SHOP DRAWINGS — ELECTRICAL / AGL SCOPE

RECTIFICATION OF TWY E BETWEEN E4 & E6 (ZIA)
AGL WORKS AT THREE (3) MILLING LOCATIONS — FIELD CONDITION SCOPE

Document No.	AUH-SK-AGL-TWYE-001 (sheets 1001 / 1002 / 1003) · Revision P08 — FINAL SCOPE OF WORK
Basis of scope	Final scope of work issued 30.07.2026 — supersedes the Rev P06 / P07 field-sheet quantities. Field verification sheets: Document_3 (LOC-01) · Second_milling_area rev _1 (LOC-02 / LOC-03).
Base layer	As-built AGL fitting positions (per assets_20260726120533.xlsx). AS PLOTTED they are ZIA LOCAL PROJECT GRID (m), matching the ADA source drawing to sub-millimetre — NOT UTM 40N. The Rev P05 EPSG:32640 label was incorrect — see sheet 6.
Prepared by	Mohammed — AGL Team Leader, ADB SAFEGATE AGL Team · Issued 28.07.2026 · Rev P08 30.07.2026

SCOPE OF WORK & SEQUENCE — TWY E (E4–E6) · REV P08 (FINAL SCOPE)

LOCATION 1 — 1001 · REV P08 (FINAL SCOPE)

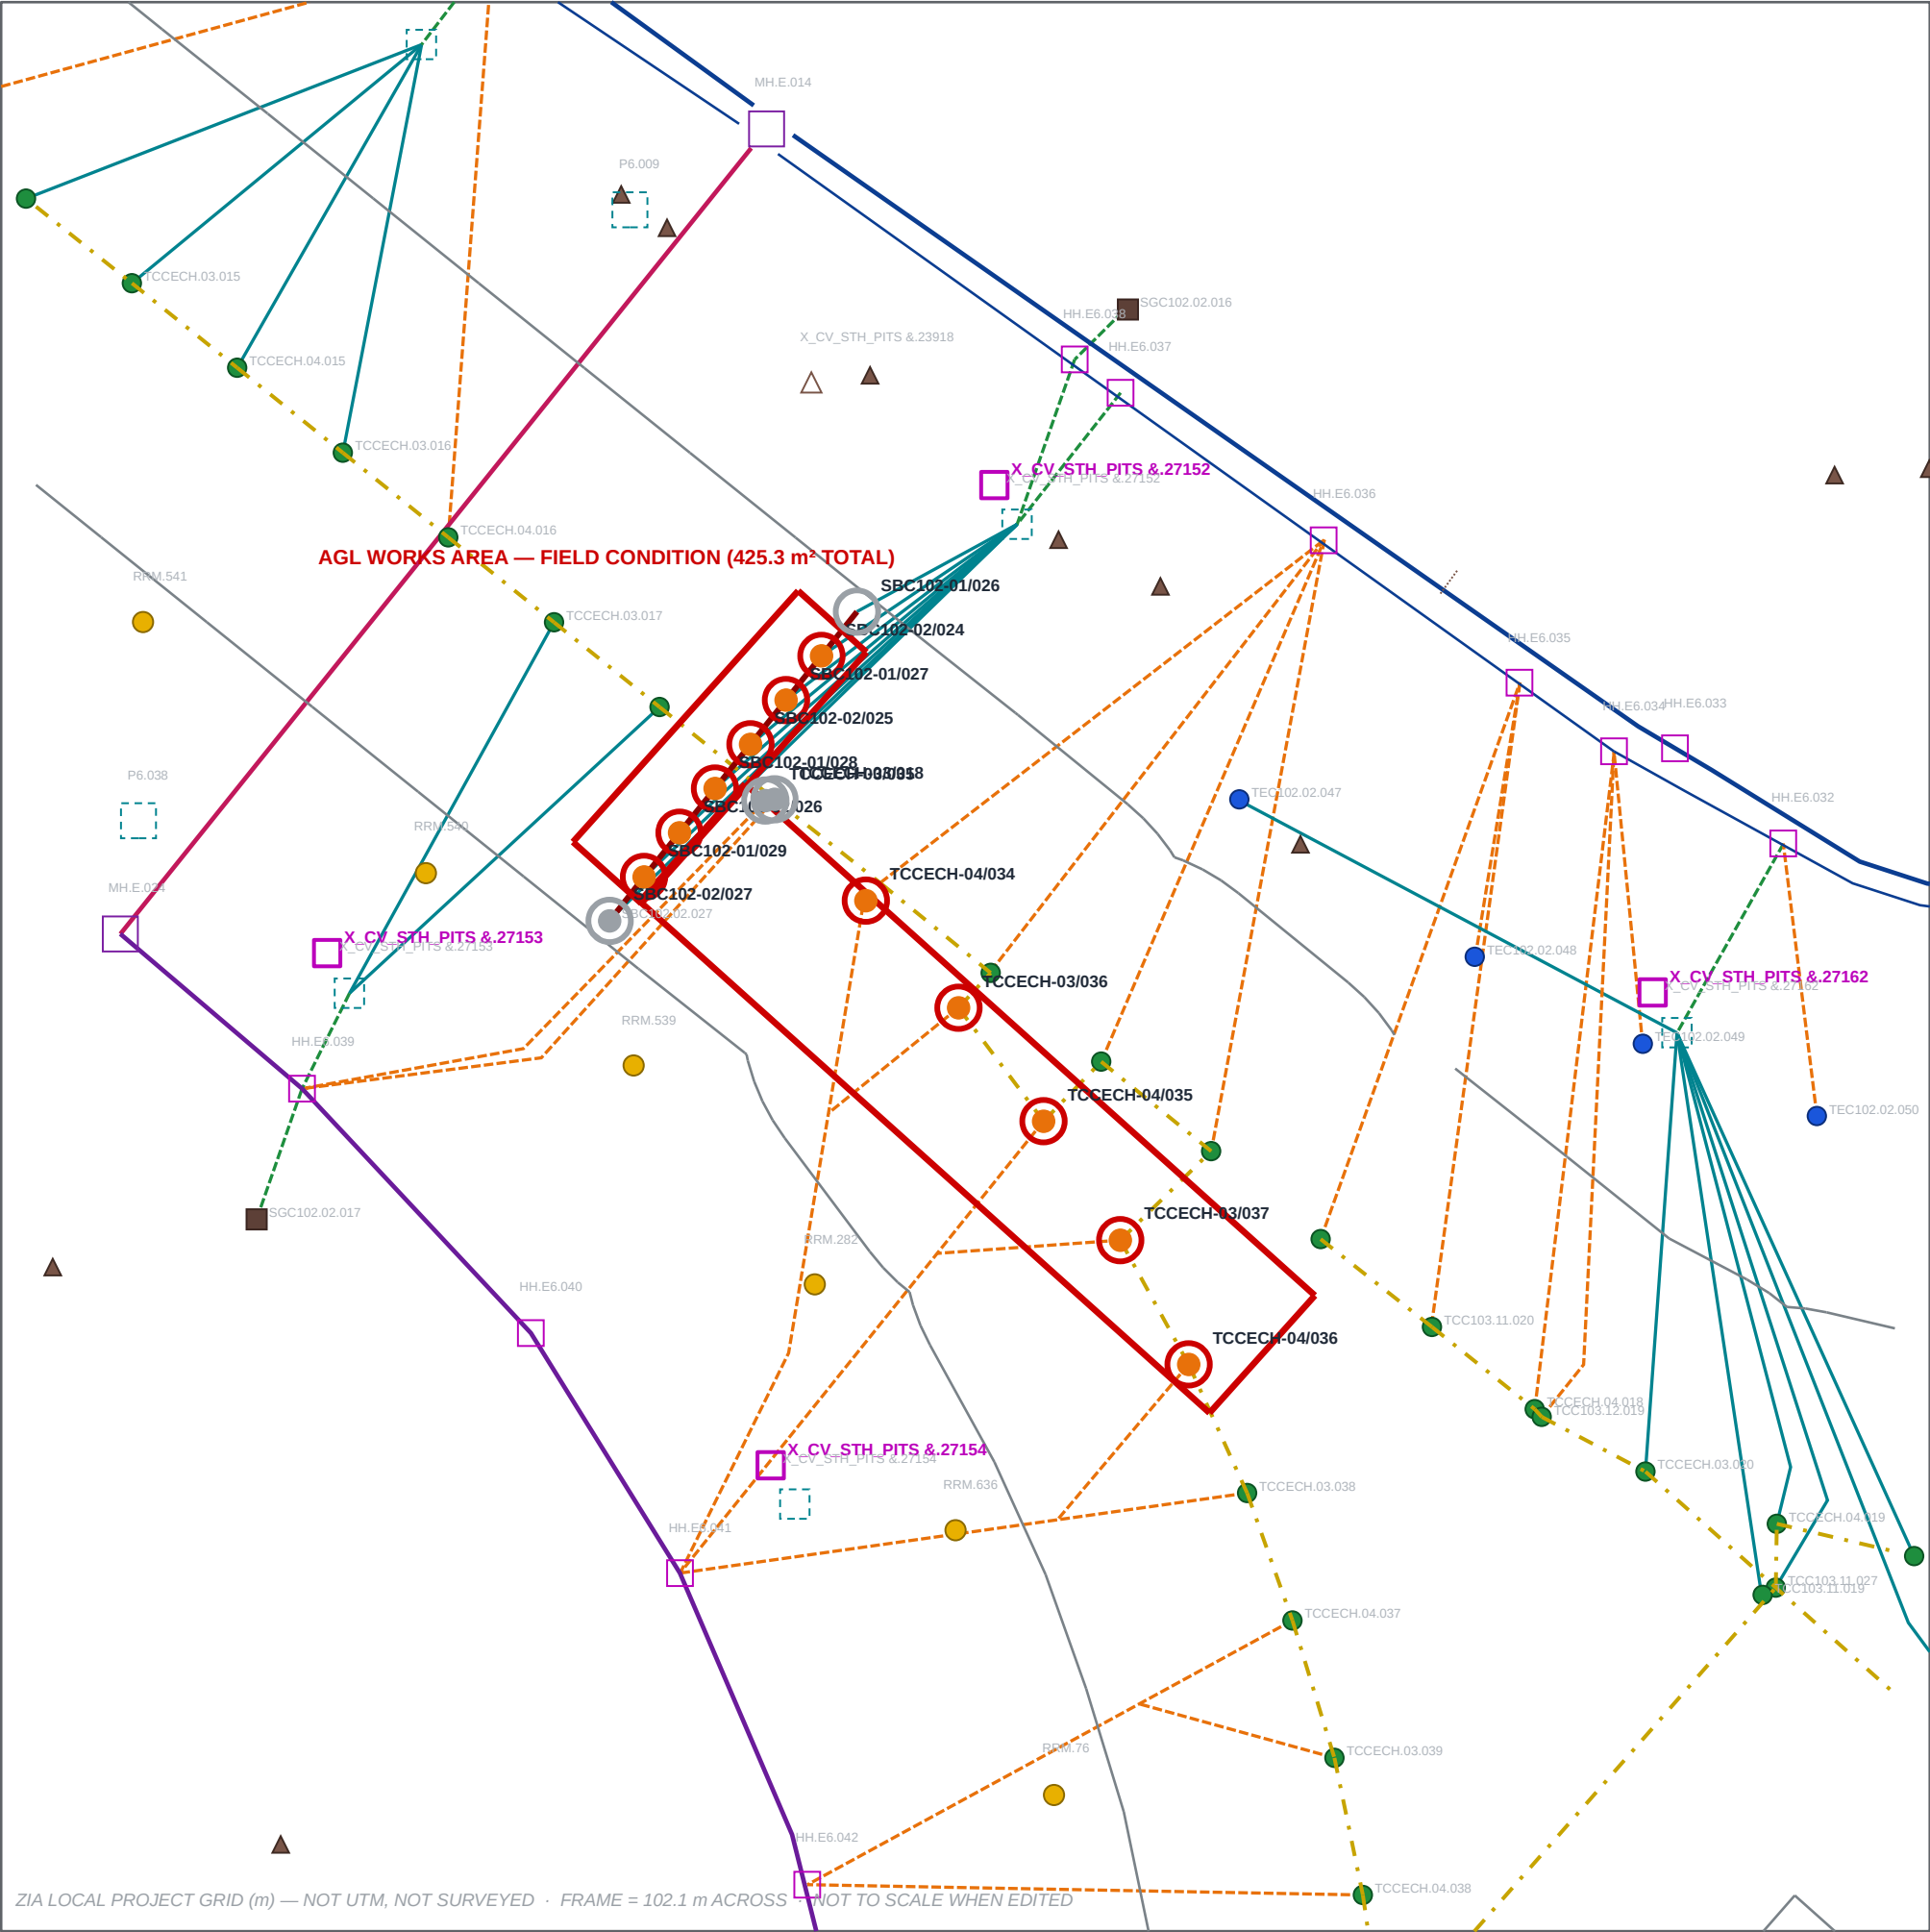
FINAL SCOPE (REV P08) — ALL 11 FITTINGS CORED, ALL ROUTES SAW CUT
CORE OUT 8" + NEW SIDE-ENTRY SHALLOW BASE + NEW CABLE: 11 No.

- SBC (6): SBC102-02/024, 01/027, 02/025, 01/028, 02/026, 01/029
- TCC (5): TCCECH-04/034, 03/036, 04/035, 03/037, 04/036

ROUTE: SAW CUT throughout — the 6 No. SBC carried as VIA DUCT on Rev P06/P07 are saw cut at P08.
Saw cut detail per sheet SAW CUT & SIDE-ENTRY SHALLOW BASE DETAIL — detail drawing to be issued.

REMOVED FROM SCOPE AT REV P08 — no works: SBC102-02/027, TCCECH-03/035, TCCECH-03/018
FIELD VERIFIED NOT AFFECTED: SBC102-01/026 (no works)
TCC103 FITTINGS NOT IN FIELD SCOPE — SHOWN AS EXISTING ONLY
ISOLATE CIRCUITS: SBC102.01/.02, TCCECH.03/.04
SITE RECORD 23.07.2026: 9 cored + 2 reinstatement already worked
REV P08 SUPERSEDES the Rev P06/P07 quantities. SUPERSEDED = no works; NOT a field verification that the asset is unaffected.
RED AGL WORKS AREA = Rev P05 field-condition milling extent, UNCHANGED at P08 — the civil milling limit, not a hull of the affected assets.

LOCATION 2 — 1002 · REV P08 (FINAL SCOPE)

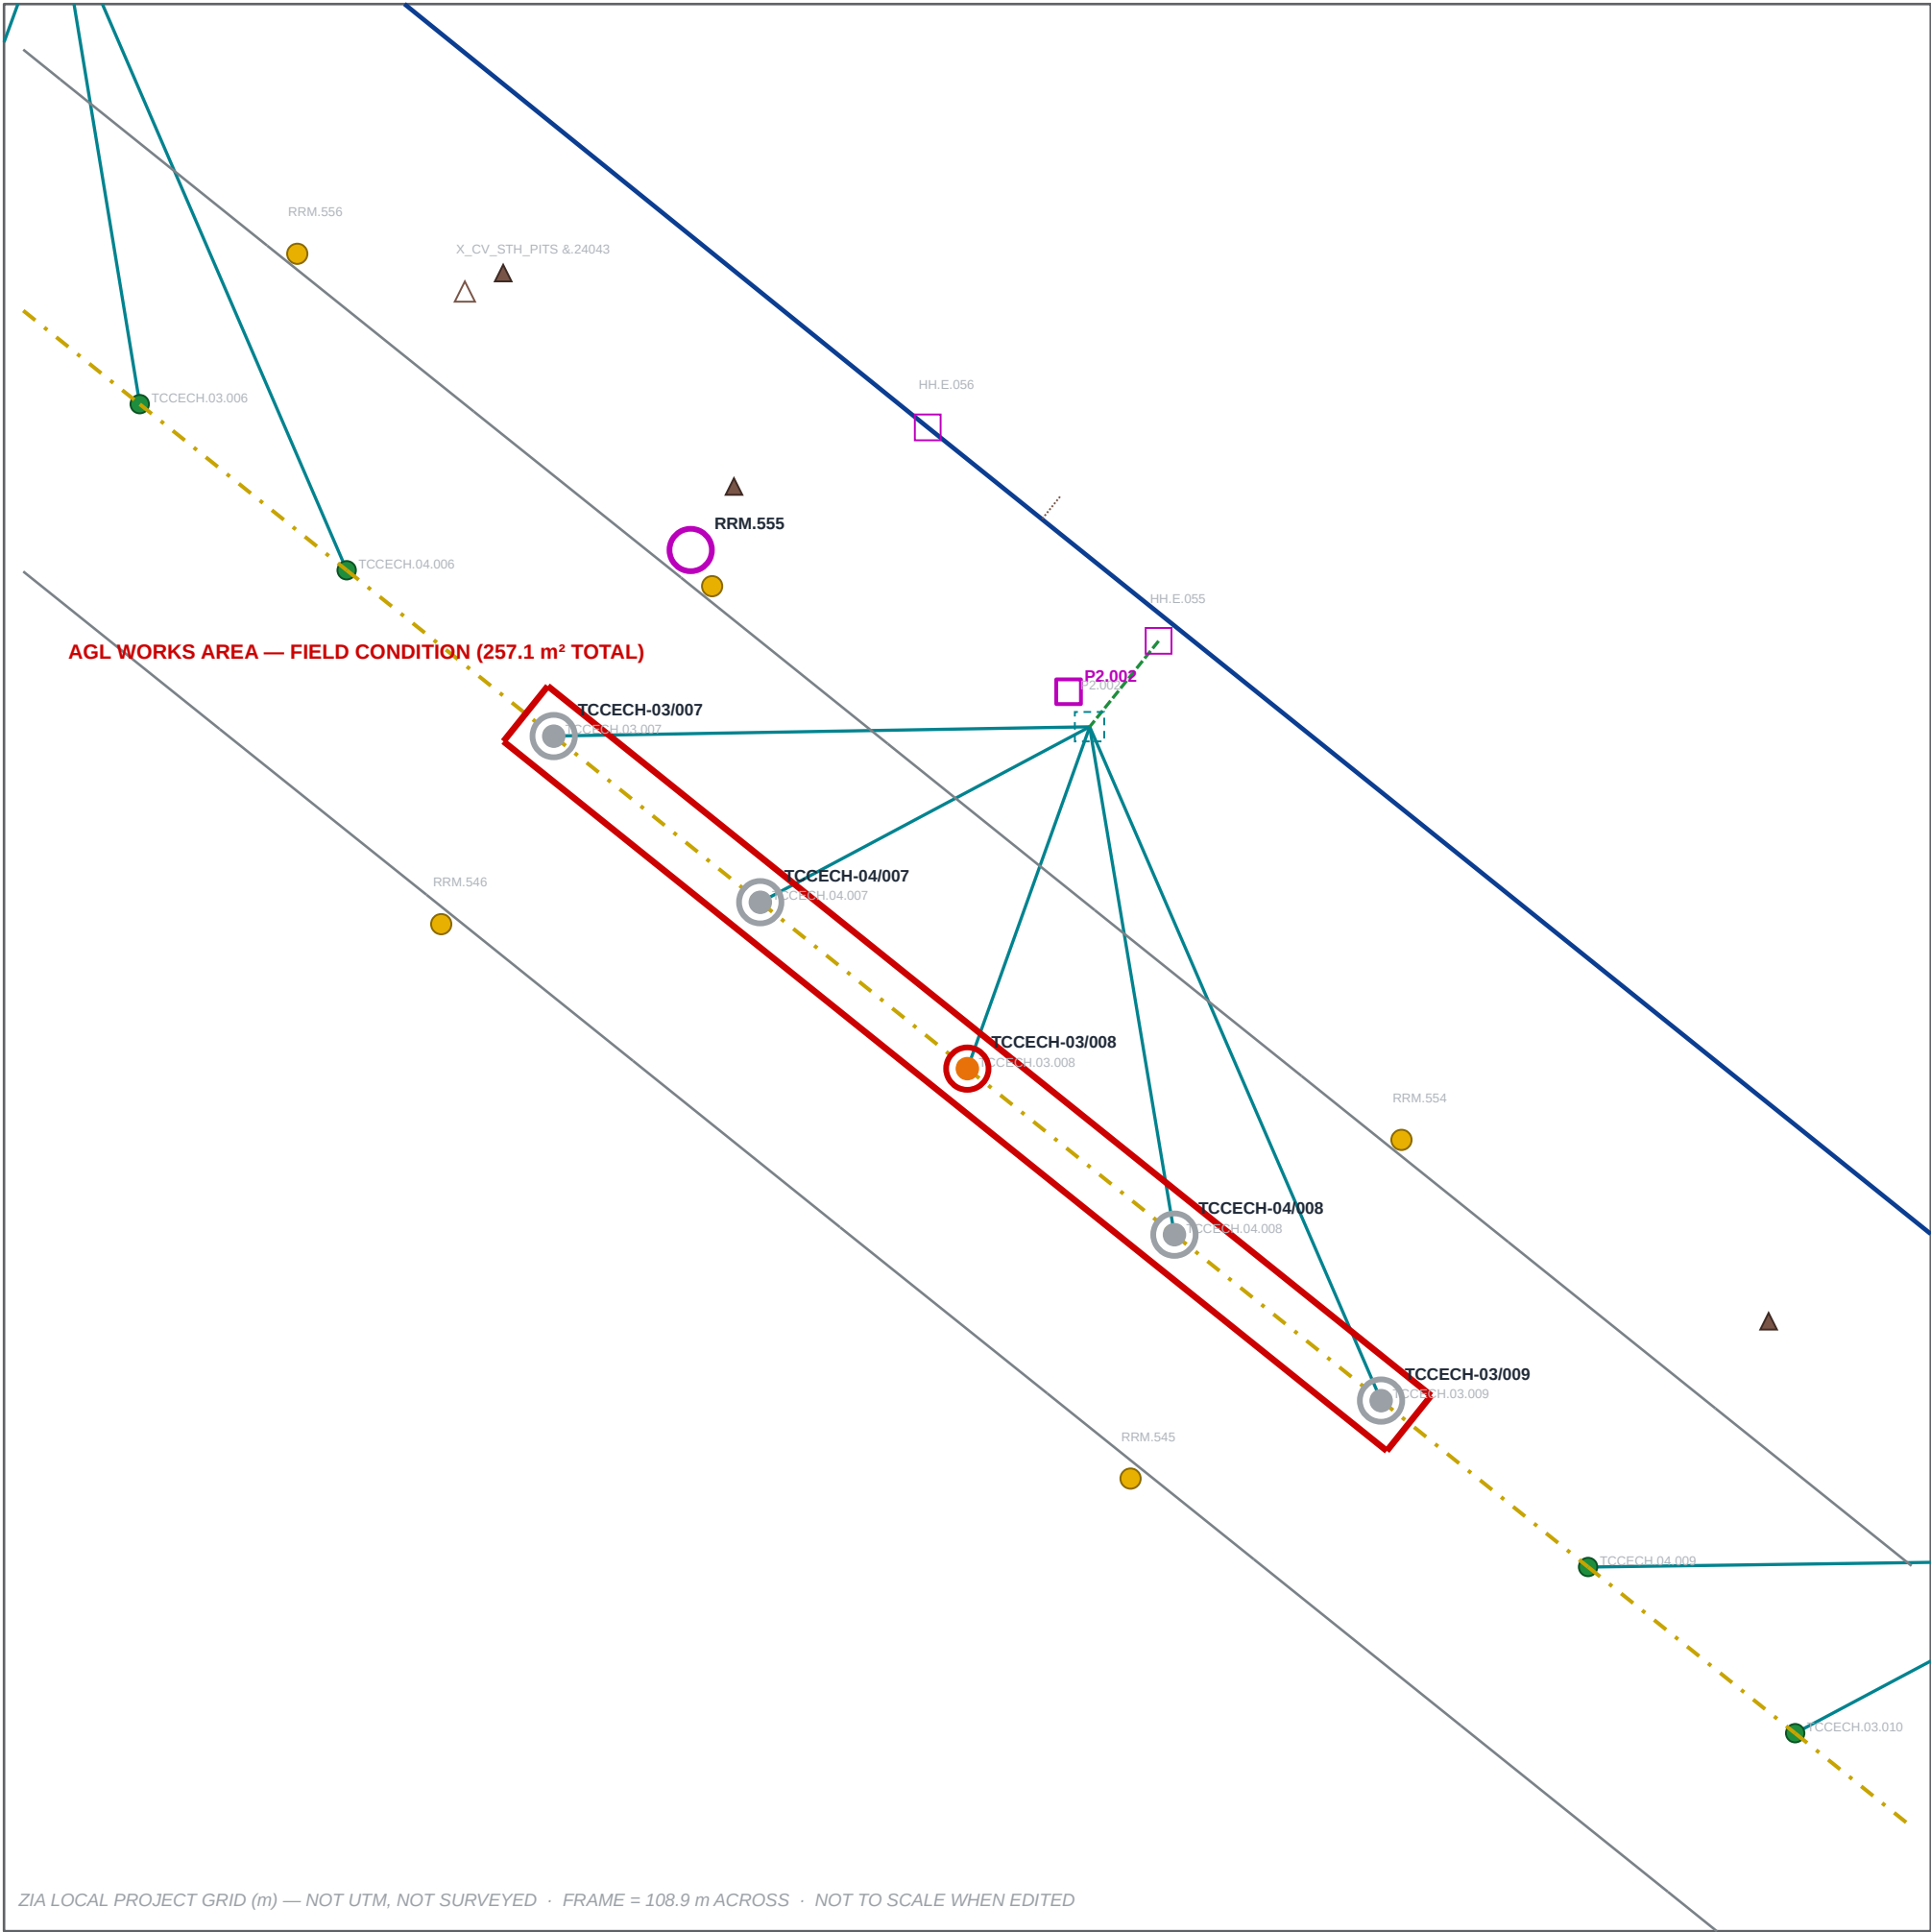
FINAL SCOPE (REV P08) — ONE FITTING AFFECTED, SAW CUT
CORE OUT EXISTING SHALLOW BASE + NEW 12" SIDE-ENTRY SHALLOW BASE + NEW CABLE: 1 No.
• TCCECH-03/008 — secondary route saw cut; existing shallow base cored out; new 12" side-entry base
Saw cut detail per sheet SAW CUT & SIDE-ENTRY SHALLOW BASE DETAIL — detail drawing to be issued.
REMOVED FROM SCOPE AT REV P08 — no works: TCCECH-03/007, 04/007, 04/008, 03/009
Rev P06/P07 carried all 5 No. as new-secondary-cable-only via duct. The final scope names 03/008 only.
RRM.555 (0.41 m from cut): REMOVE / PROTECT BEFORE SAWCUT, RE-FIX AFTER PAVING
ISOLATE CIRCUITS: TCCECH.03, TCCECH.04
REV P08 SUPERSEDES the Rev P06/P07 quantities. SUPERSEDED = no works; NOT a field verification that the asset is unaffected.
RED AGL WORKS AREA = Rev P05 field-condition milling extent, UNCHANGED at P08 — the civil milling limit, not a hull of the affected assets.
